PCN/17/010/C+N-US

Product range: M8 Connectors

Title: Injection Molding Change for M8 Sealing Comb

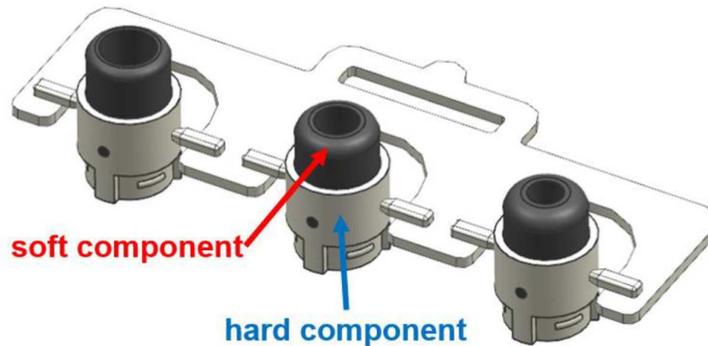
We would like to inform you about a change of the injection molding process for the sealing comb used in our M8 connectors. We changed the order of the injected components during the injection molding process, so that the hard component is injected as the first step and the soft components as the second step.

Current Sealing Comb

New Sealing Comb

The above-mentioned change has no impact on the function, product specification or the IP rating of these connectors. All outer dimensions of the sealing remain the same and have no influence on the assembly process.
